**GRAND JUNCTION CITY COUNCIL
MINUTES OF THE SPECIAL MEETING**

June 28, 1999

PUBLIC HEARING – APPEAL OF PLANNING COMMISSION DENIAL OF A GROWTH PLAN AMENDMENT, REZONE REQUEST AND A SITE SPECIFIC DEVELOPMENT PLAN FOR PROPERTY LOCATED AT THE SOUTHEAST CORNER OF 12TH STREET AND PATTERSON ROAD FROM RSF-8 AND PB TO B-3 (CITY MARKET)[File #RZ-1998 & SDR-1998-129]

METS/DIG/DMC
CityMarket
 AMENDED SITE PLAN
 SHEET 12
 12/11/2010

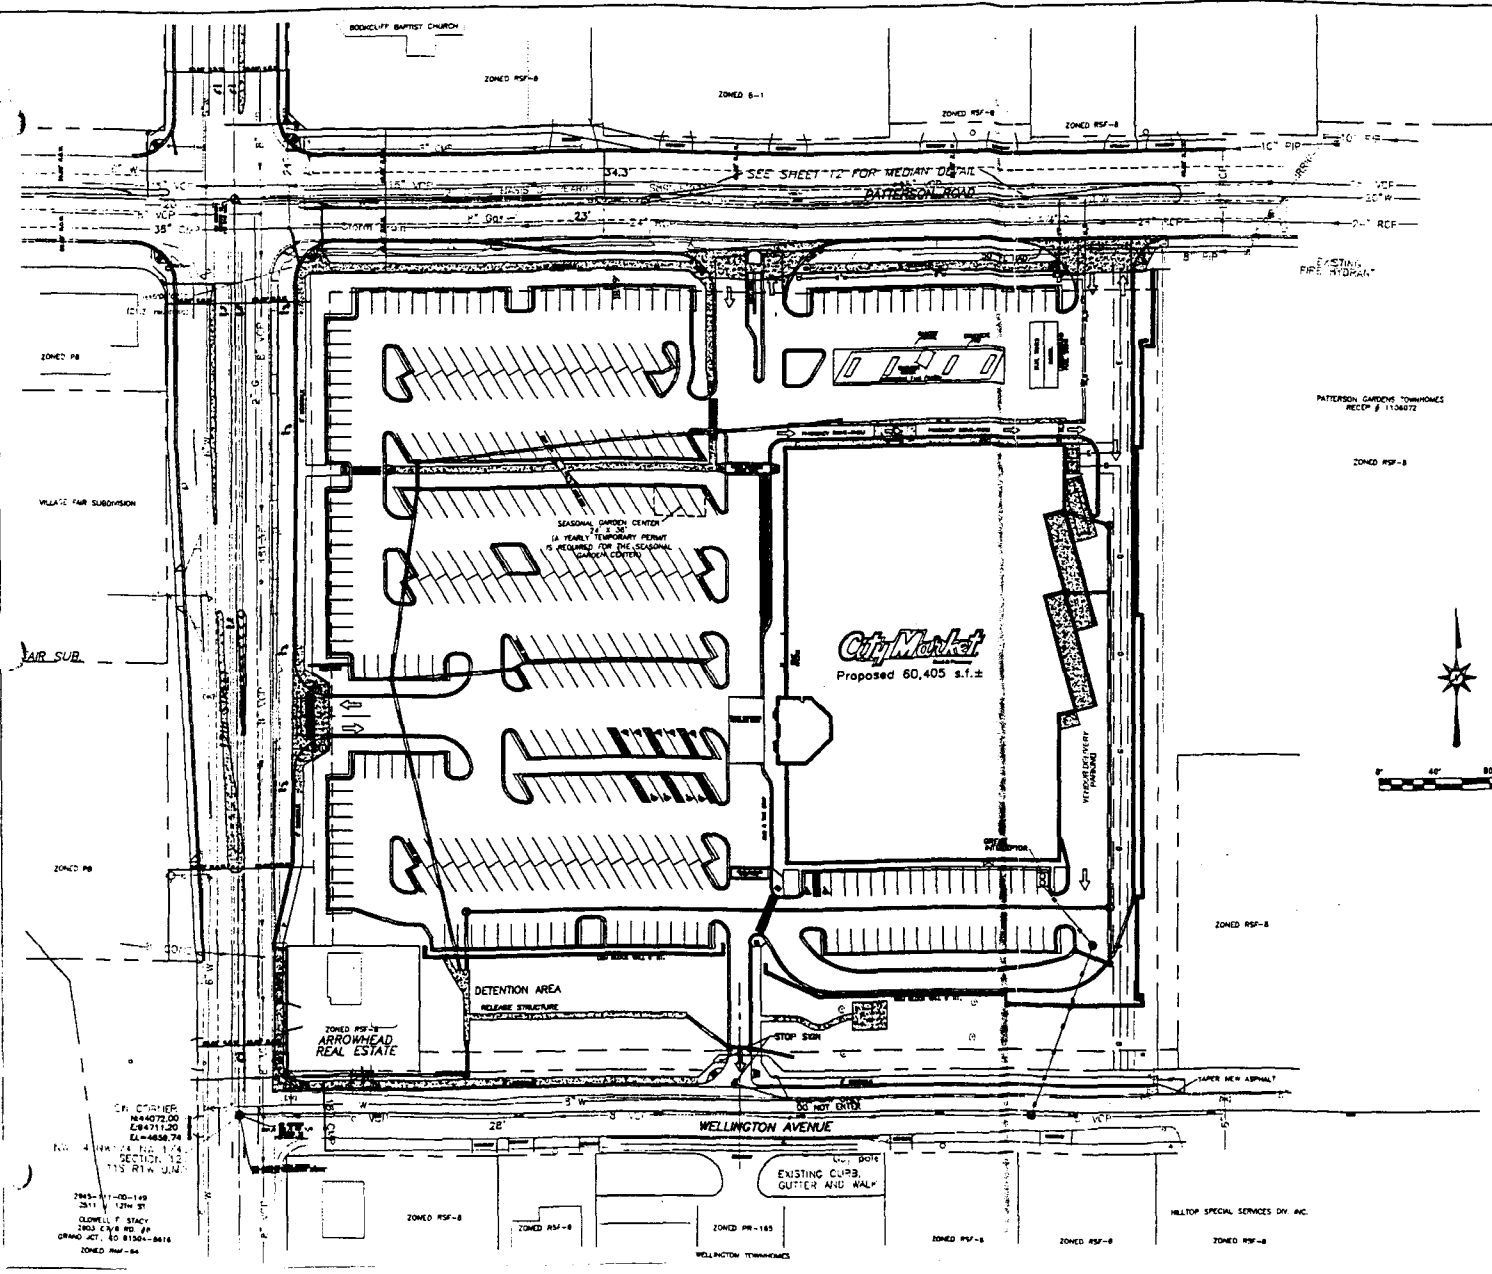
At the Planning Commission hearing City Market presented this amended site plan for the Planning Commission's consideration. This alternative limits the access onto Wellington Avenue to one exit-only driveway. City Market may be requesting that City Council also allow them to present this alternative design; however the staff report is based on the original site plan.

ROLLAND ENGINEERING 403 River St Grand Jct., CO 81501	8030MST.DWG
	OVERALL SITE PLAN

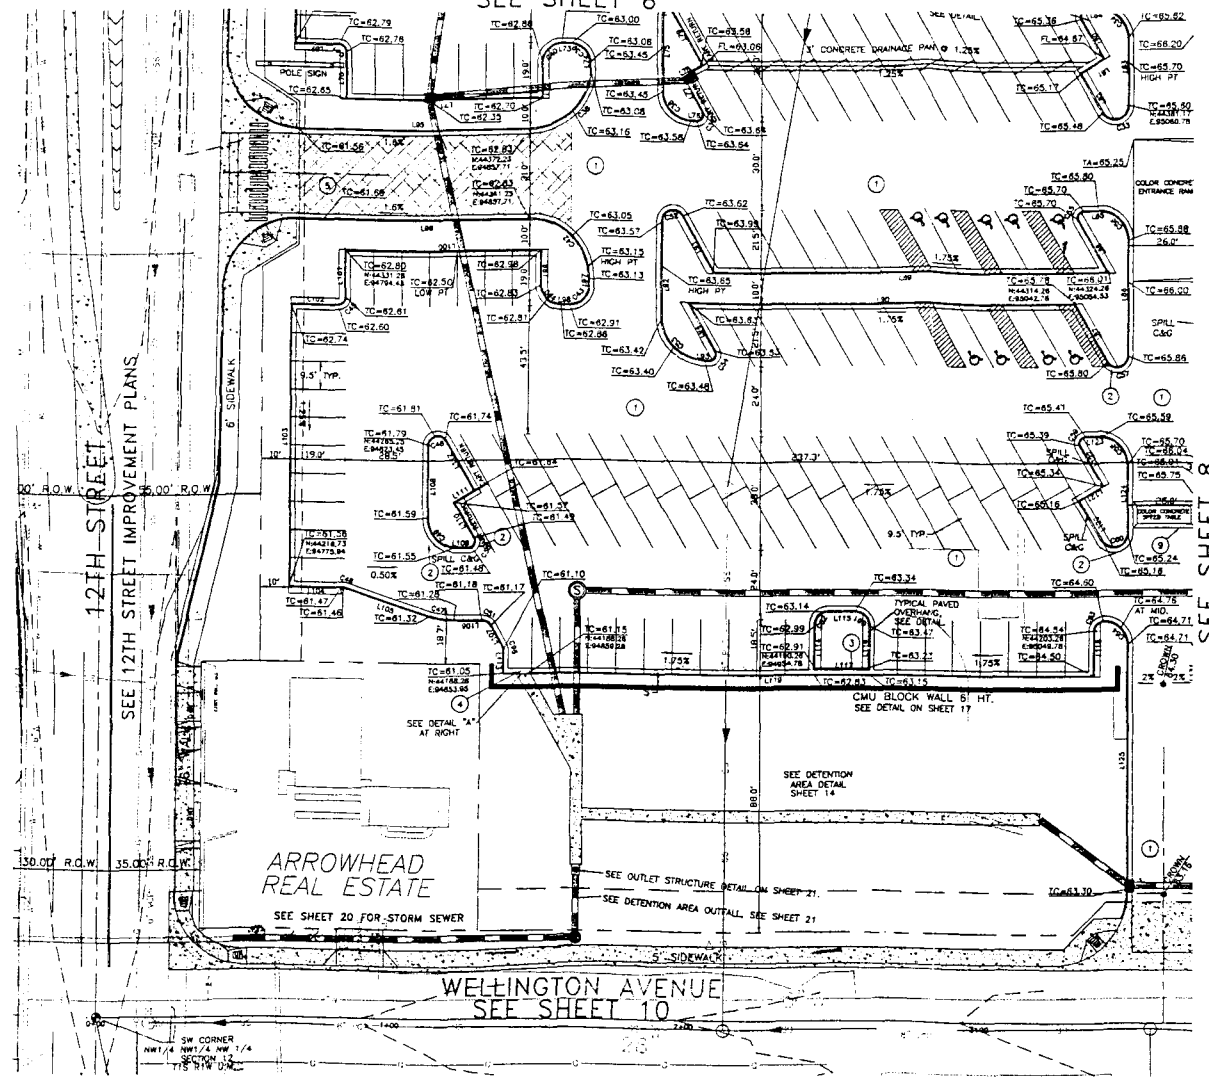
Sheet 5 Overall Site Plan

Design sheet 5 is revised to illustrate that a second driveway exists on the east side of this property described above. Per Staff's request, the east end of the Patterson Road median is extended to east so that the east end of the median is in alignment with the eastern edge of the west driveway on the property described above.

Design sheet 5 has been revised to illustrate the medians and lanes.

Design sheet 5 has been revised to illustrate driveways opposite and adjacent to the site.

ARK:8030PPAT.DWG
tyMarket
 PATTERSON ROAD
 PLAN & PROFILE

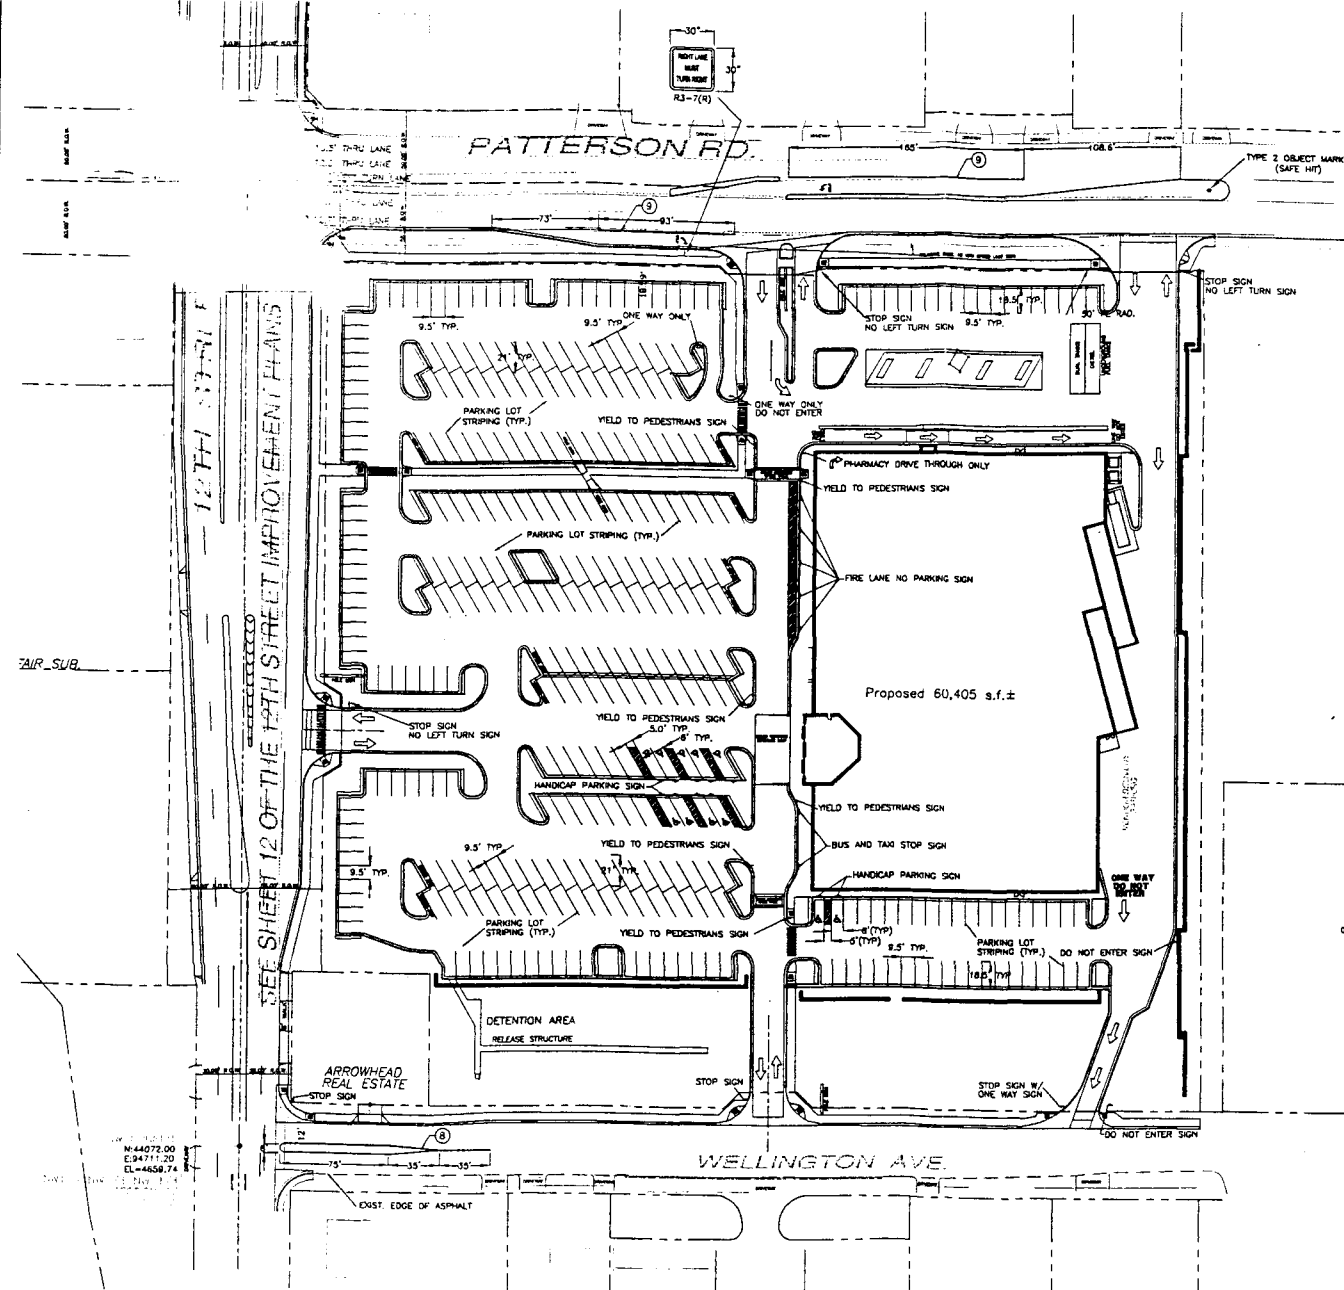
Sheet 12 Patterson Road Plan and Profile

2. Show driveways opposite from the site.
Driveways opposite the site are shown on the revised plan.
3. Prepare a signing and striping plan in accordance with the MUTCD for Patterson Road. Include existing signing and striping to remain and show any necessary modifications to existing. Label lane and median widths.
A revised signing and striping plan in accordance with the MUTCD is included in the revised plan set on sheet 23 of 32. Lane widths on Patterson are only illustrated just beyond the intersection with 12th Street with Staff's approval.

4. Provide a detail for the median construction. Match the existing median as noted above (curb with concrete between).
Details for the median construction are provided on the revised plan set on design sheet 3 as referenced on design sheet 12 .

5. From the cross-sections, it is apparent that the median will be trapping some runoff from the crown of the road. Provide a collection point, inlet and pipe into the storm sewer, Show the crown line of the road on the plan.
Per subsequent meetings with Staff, it is not necessary to provide an inlet and piping to the storm sewer. The crown line is illustrated on design sheet 13.

Project: 180305CH.DWG CityMarket STRIPING AND SIGN PLAN
	ROLLAND ENGINEERING 435 1/2 Street Street Grand Jct. CO 81503 Designer: TDR Checker: TDR Plot: 8030 Sheet: 23

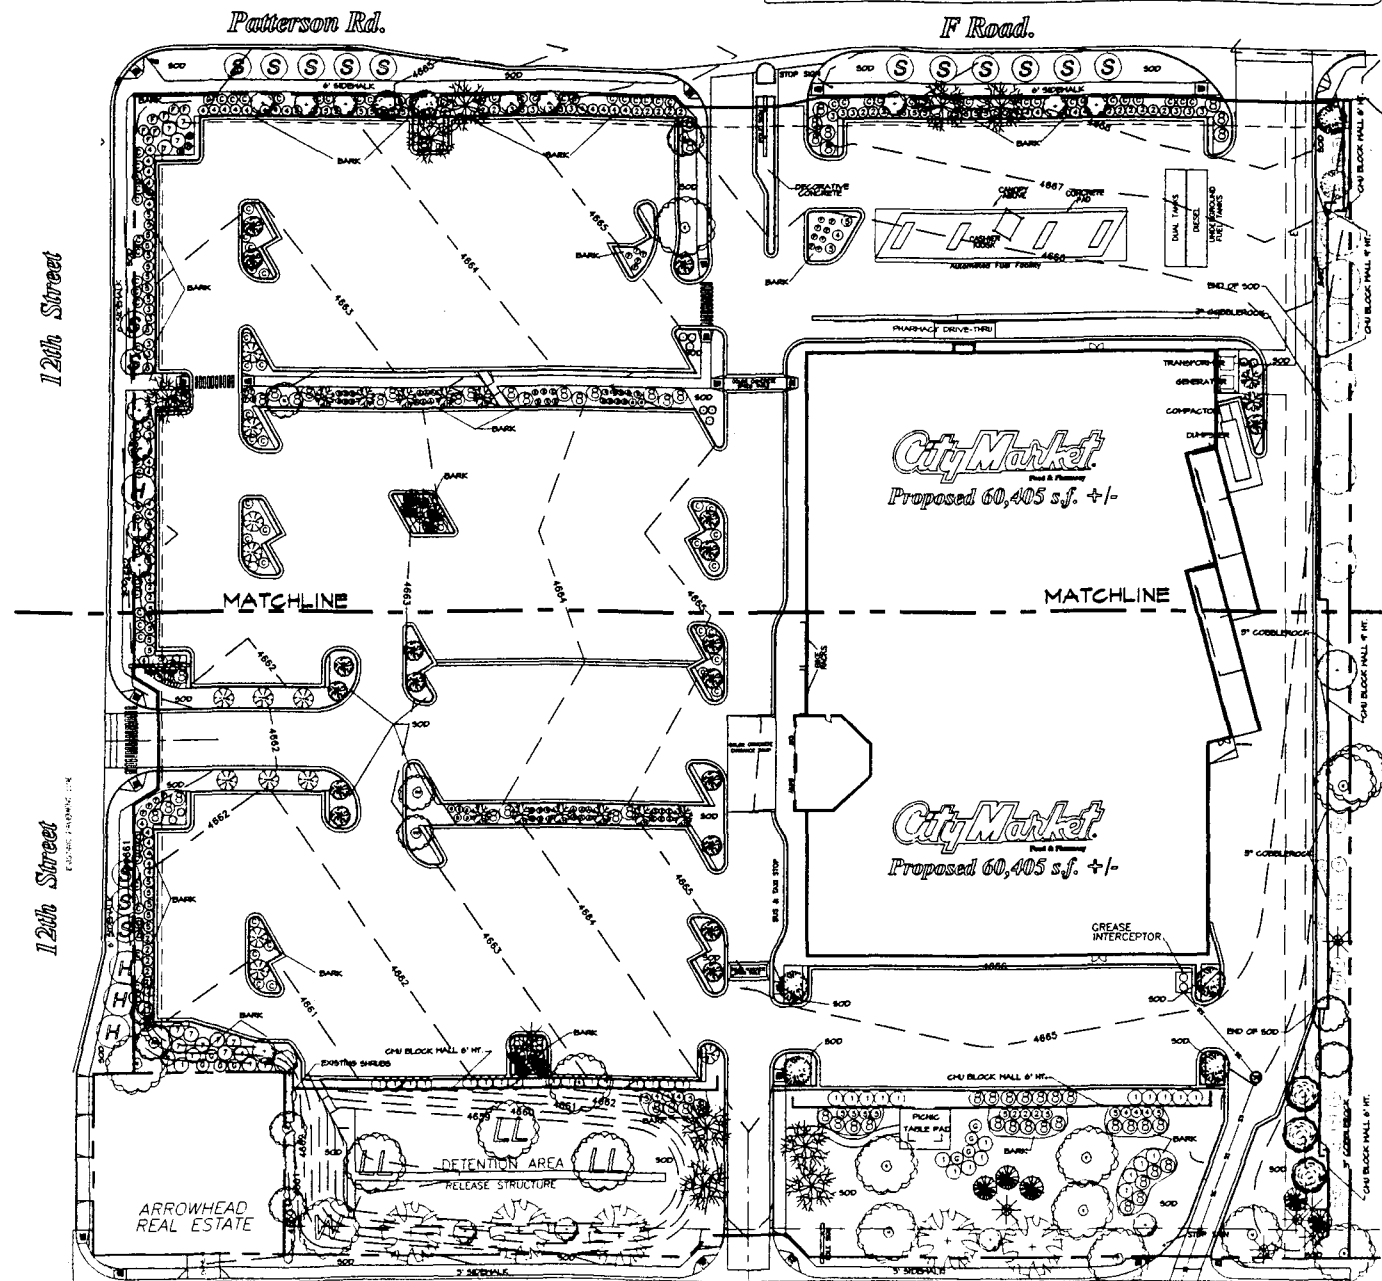
Sheet 23 Striping and Sign Plan

1. Note that this sheet is for on-site striping and signing only.
Staff has approved providing on-site and off-site signing and striping on the same design sheet. Sheet 23 illustrates both on-site and off-site signing and striping.
